## Europe (CE) TS Transfer Abutment Improved Screw

## **New Screw**

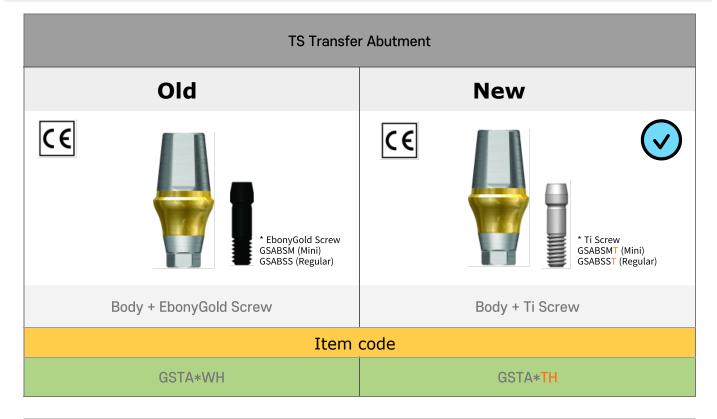
- TS Transfer Abutemnt screw improvement
- Both EbonyGold and Ti Screw are compatible
- New screw has different item codes
- Request the new screw after the old screw are sold-out (Running change)

- Ti Screw with a speical metal process to improve strength and screw loosening
- 1 more thread added
- Improved fatigue loosening and fatigue life
